Re: Indian Point Unit No. 2
Docket No. 50-247
NL-04-095

**SUBJECT: Reply to Supplemental Request for Additional Information Regarding
Indian Point 2 Stretch Power Uprate (TAC MC1865)**

**REPLY TO NRC REQUEST FOR ADDITIONAL INFORMATION REGARDING
PROPOSED LICENSE AMENDMENT REQUEST FOR
INDIAN POINT 2 STRETCH POWER UPRATE**

Figure 1: ASCO area, thermal lag and test temperatures

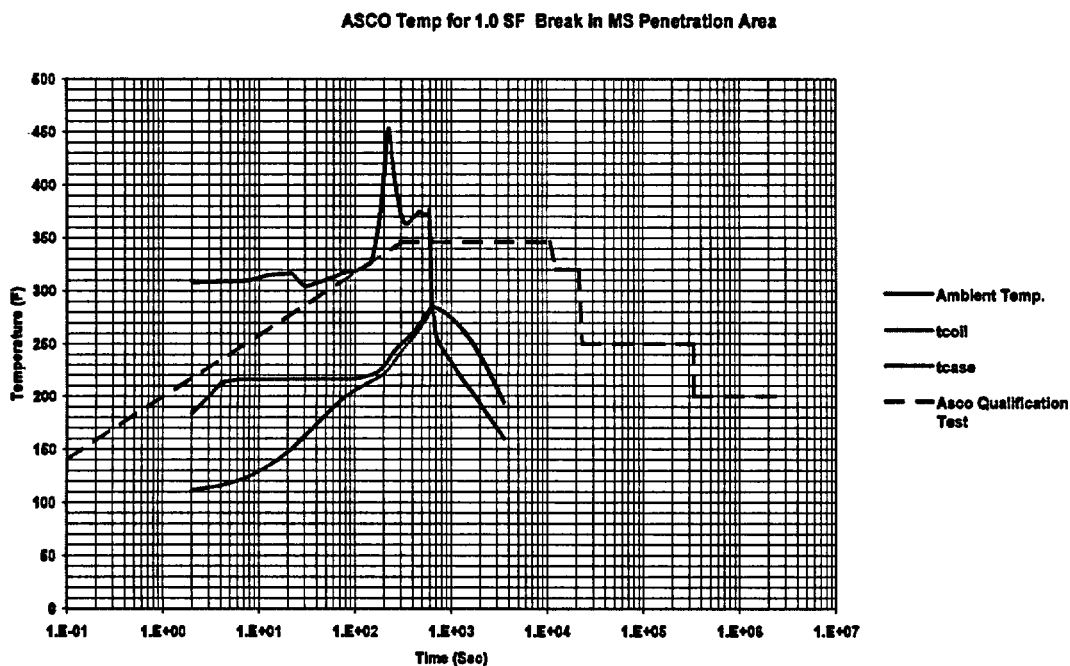
Section 10.8.4, "SPU Equipment Qualification Evaluation," states that accident temperatures outside containment in the steam and feedline penetration area have been reanalyzed and result in higher temperatures, and that all equipment outside containment required for accident response have been justified as qualified.

The ASCO solenoid valves, as well as the other equipment above, were evaluated using the thermal lag analysis of the parts for a 1.0 square foot MSLB header break (limiting break size), winter building ventilation configuration and 102% SPU power. The results are presented in Figure 1 for the ASCO solenoid valves. The temperature of the ASCO case and the coil are very close. However, the coil is only energized for 20 seconds or less to perform the safety function of tripping the MSIVs, so there is little heat generated within the component. After isolation, the MSIV is locked closed. The solenoid valve has no further safety function after the isolation.

As shown on Figure 1, the thermal lag temperature of the ASCO coil and case remain below the qualification test temperature. The qualification testing for the ASCO valves included a pre-test accident soak (continuously energized mode) to assure the ASCO valves reached the test chamber temperature.
